CALL NO. 200
CONTRACT ID NO.
131212 Addendum # 2

Subject: Marshall Trigg County, 121GR13D012 - NHPP 0801 (098)
Letting December 20, 2013

- (1) Revised - Plan Sheets - R2, S2, S134, S183, S184A, S184B, S187, S192, S194, S206, S207, S207A, S207B, S208, S208A, S208B, S209, S209A, S210, S211, S212, S213, S216, S217, S260, S261, S274
- (2) Revised - Cover Page - PAGE 1 of 403
- (3) Revised - Completion Dates - Page 4 of 403
- (4) Revised - Multiple Notes - Various Pages
- (5) Revised - Bid Items - Page 397-403 of 403
- (6) Delete - Pages 27thru44, 216thru233, 207thru215, 234thru238 of 403

6. MODULAR JOINT DIMENSIONS A, B, C, AND D SHALL BE LIMITED TO THE FOLLOWING VALUES:
 DIMENSION "A" = 35 INCHES
 DIMENSION "B" = 45 INCHES
 DIMENSION "C" = 12 INCHES
 DIMENSION "D" = 18 INCHES

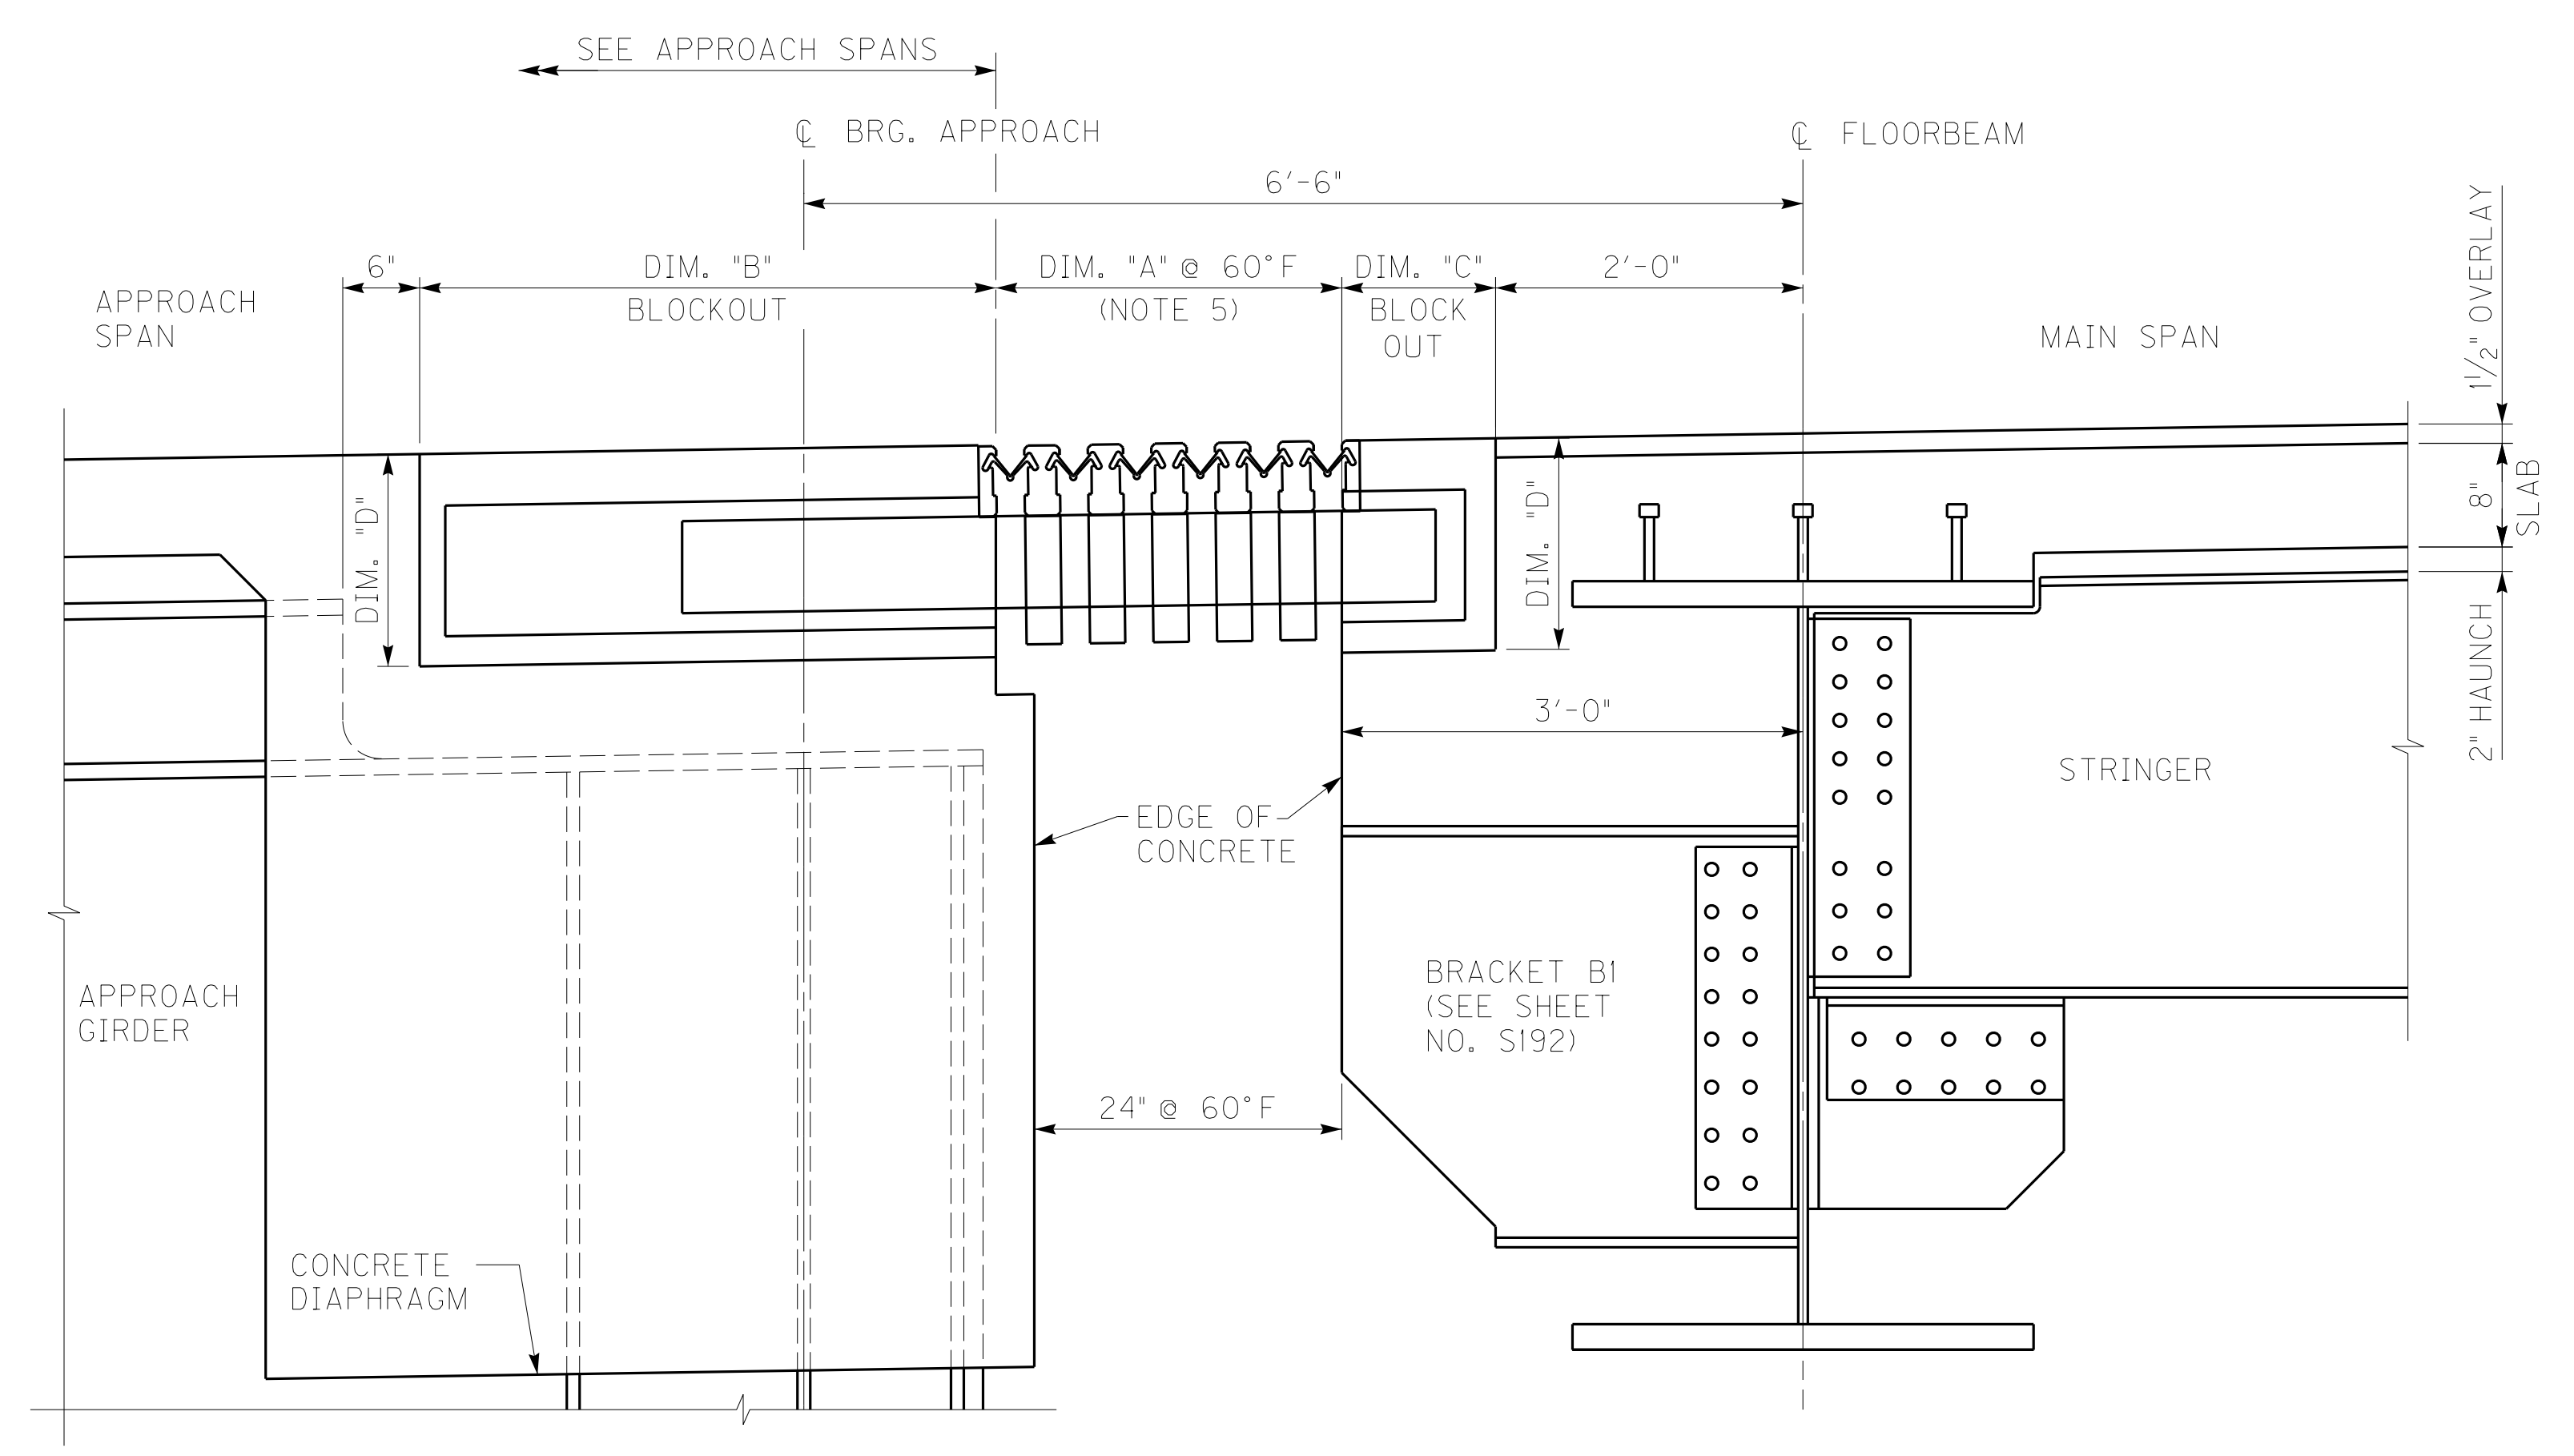
ADD NOTE 10		11/25/13
REVISION		DATE
DATE: NOVEMBER 15, 2013	CHECKED BY	
DESIGNED BY: DMB	TJT	
DETAILED BY: CDR	DMB	
Commonwealth of Kentucky DEPARTMENT OF HIGHWAYS		
COUNTY MARSHALL / TRIGG		
ROUTE US68	CROSSING KENTUCKY LAKE	
MODULAR EXPANSION JOINT		
PREPARED BY		SHEET NO.
MICHAEL BAKER JR., INC. 9750 ORMSBY STATION ROAD SUITE 210 LOUISVILLE, KY 40223		S206
Baker		DRAWING NO. 24686

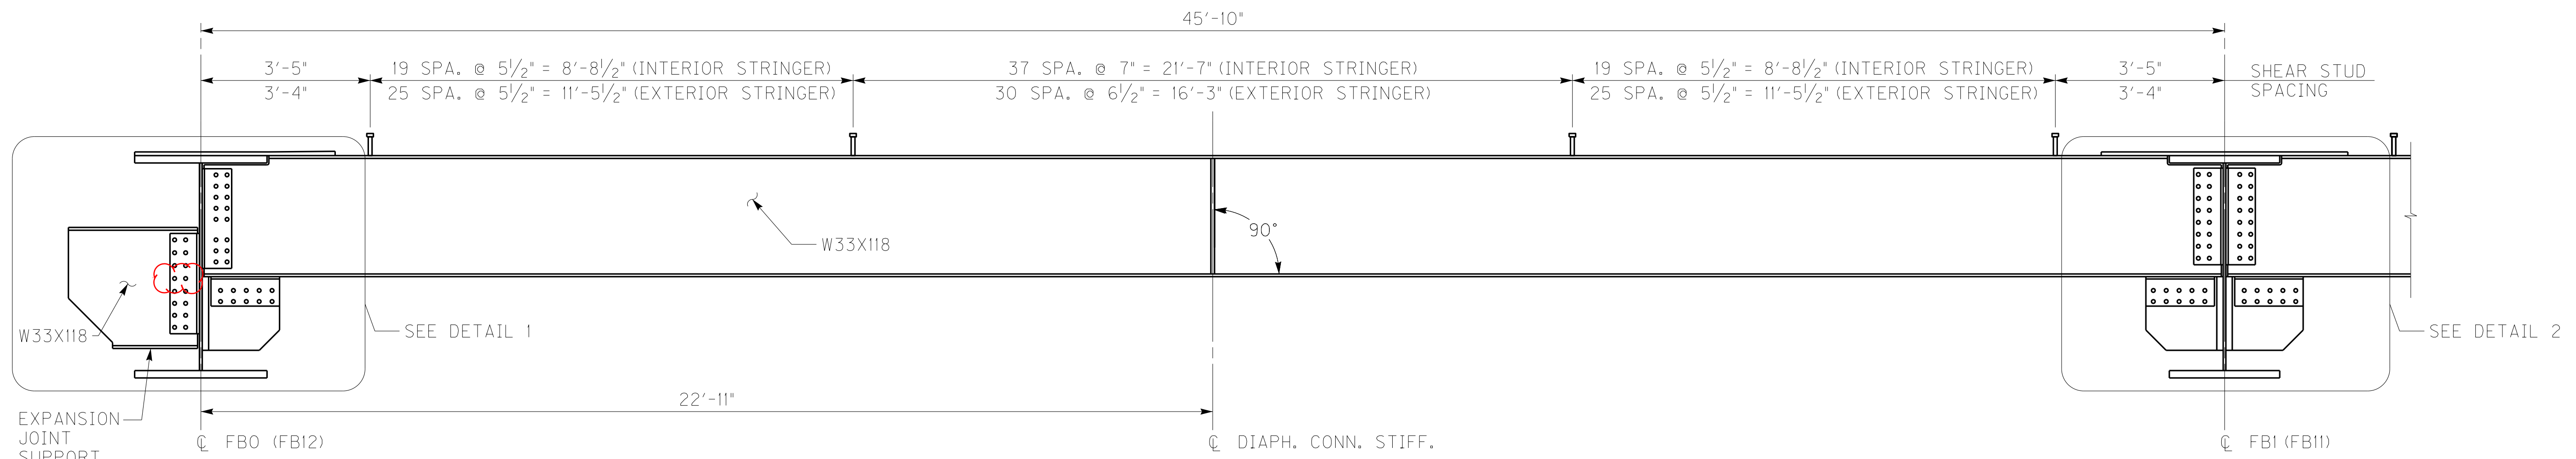
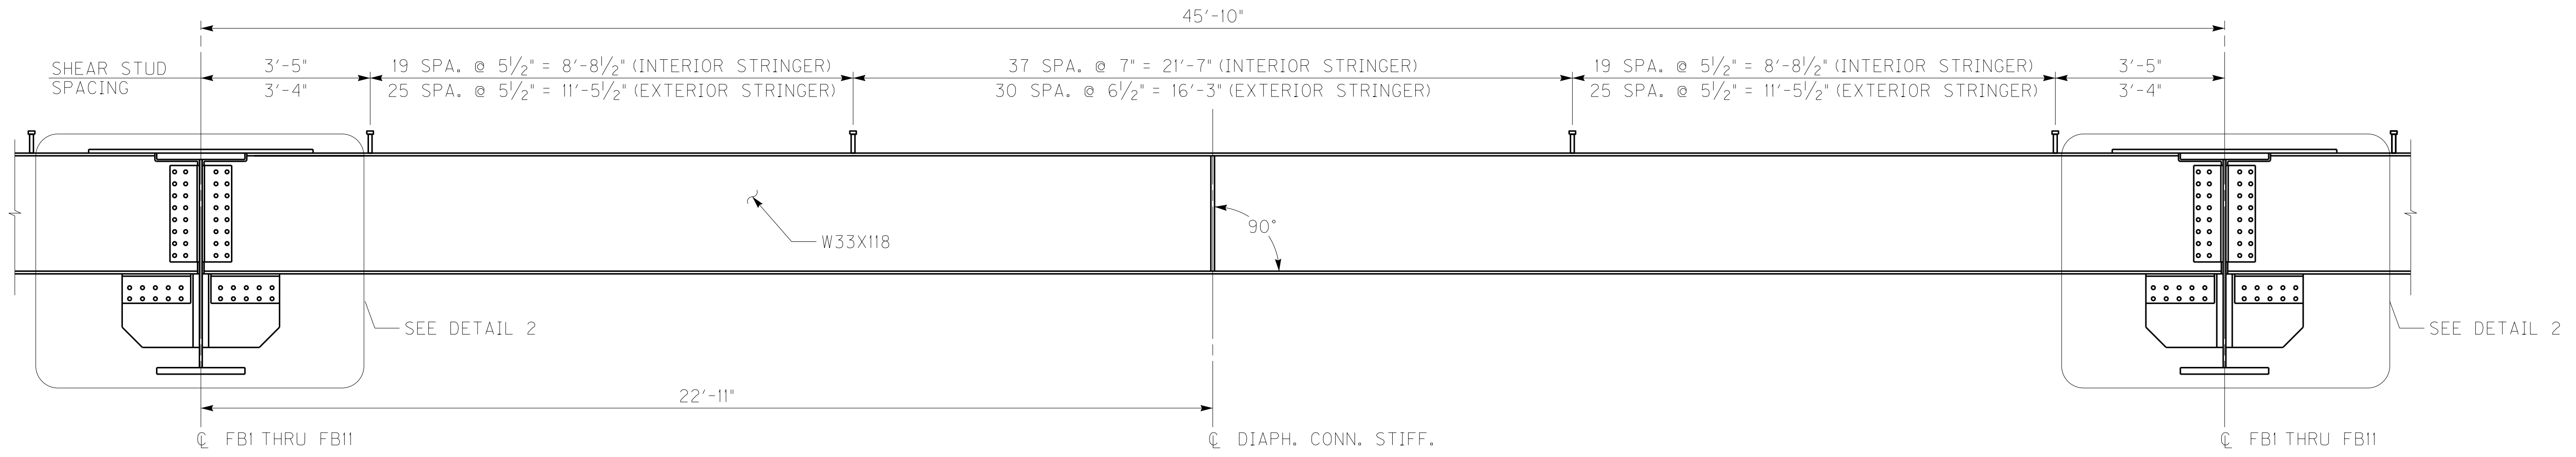
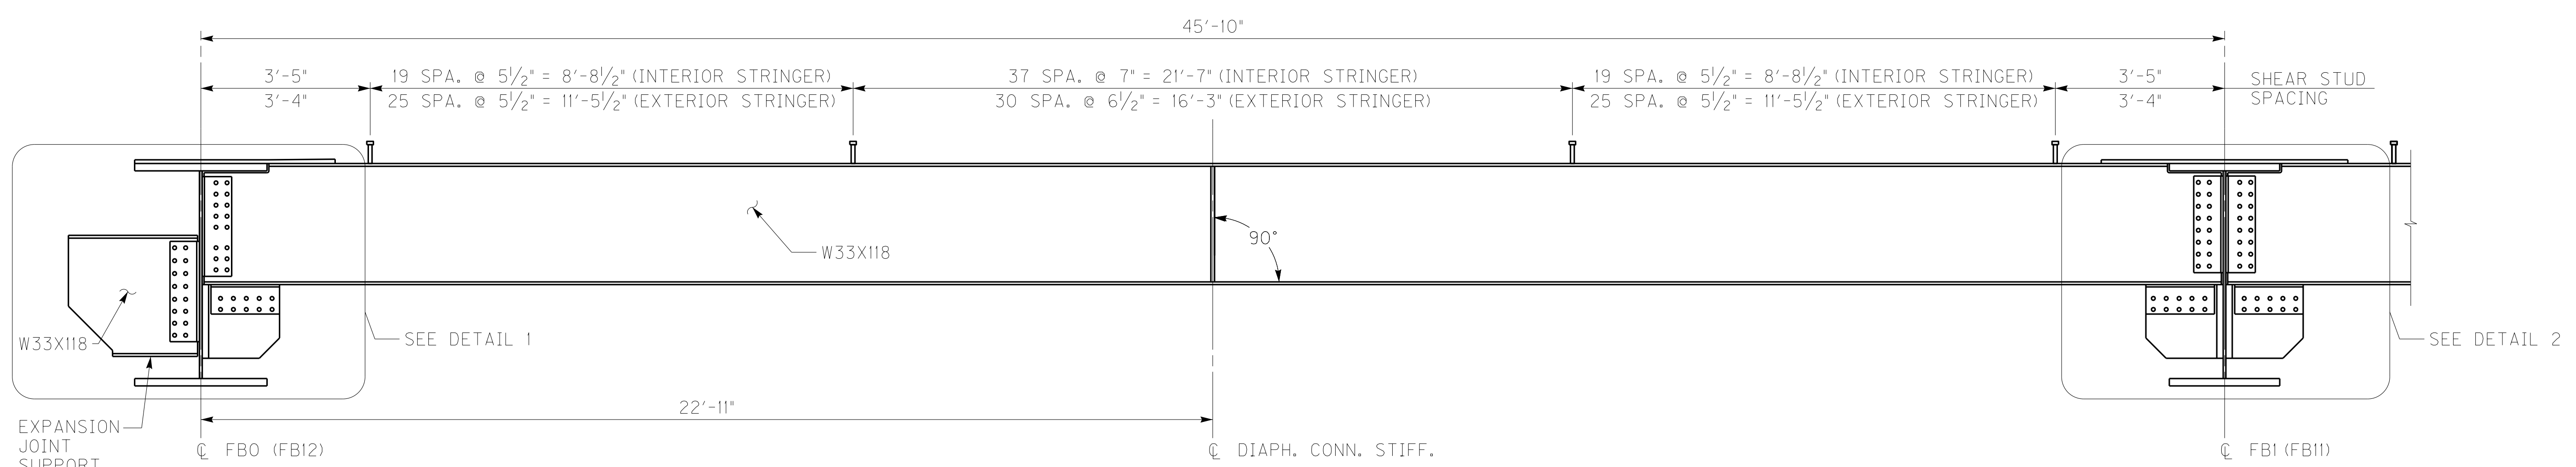
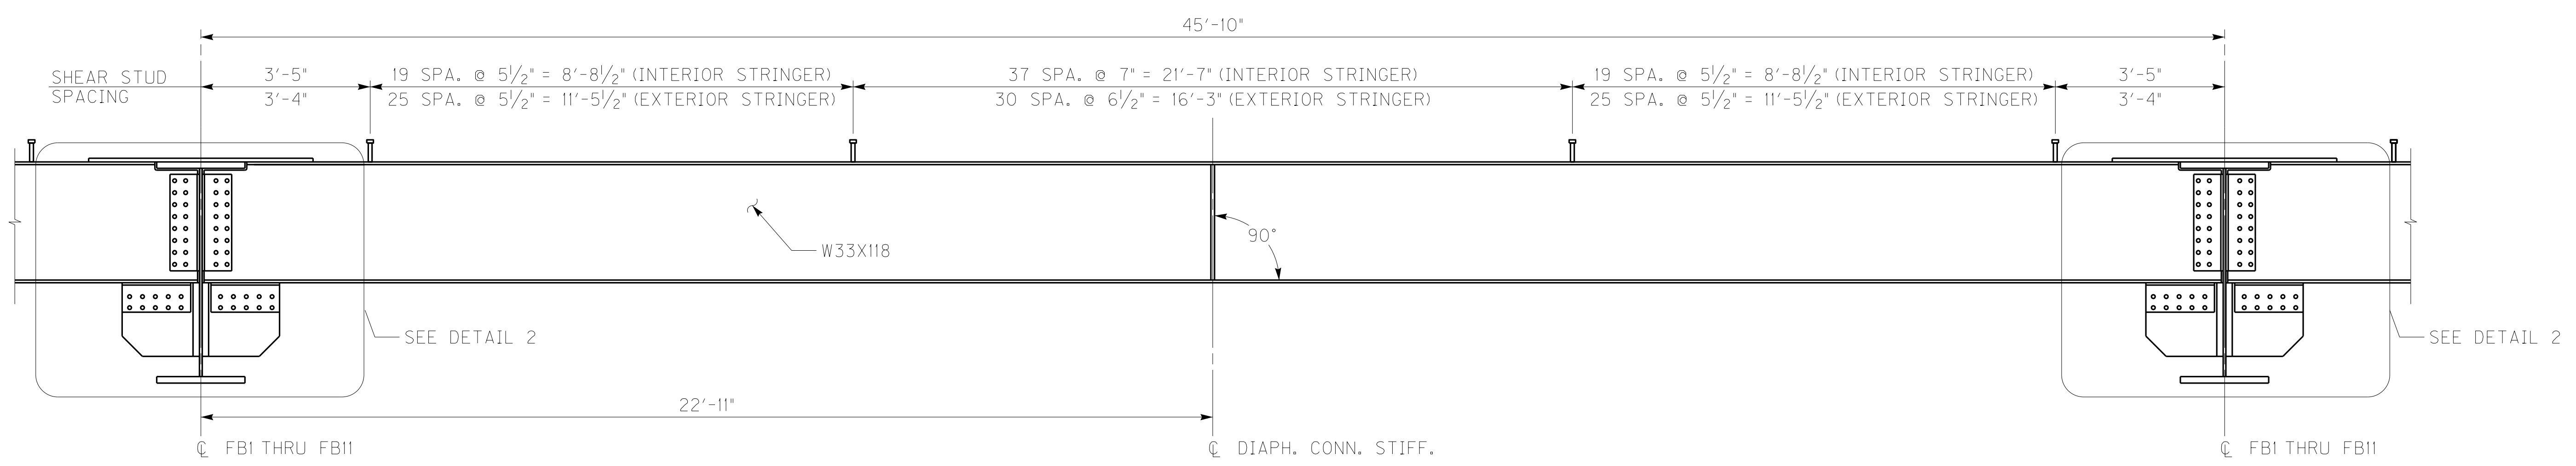
REVISION		DATE
REVISED BRACKET BI CONNECTION		11/25/13
DATE: NOVEMBER 15, 2013	CHECKED BY	
DESIGNED BY: ACK	LEV/RMS	
DETAILED BY: MJD	ACK	
Commonwealth of Kentucky DEPARTMENT OF HIGHWAYS		
COUNTY MARSHALL / TRIGG		
ROUTE US68	CROSSING KENTUCKY LAKE	
STRINGER ELEVATION		
PREPARED BY		SHEET NO.
MICHAEL BAKER JR., INC. 9750 ORMSBY STATION ROAD SUITE 210 LOUISVILLE, KY 40223		S192
Baker		DRAWING NO. 24686
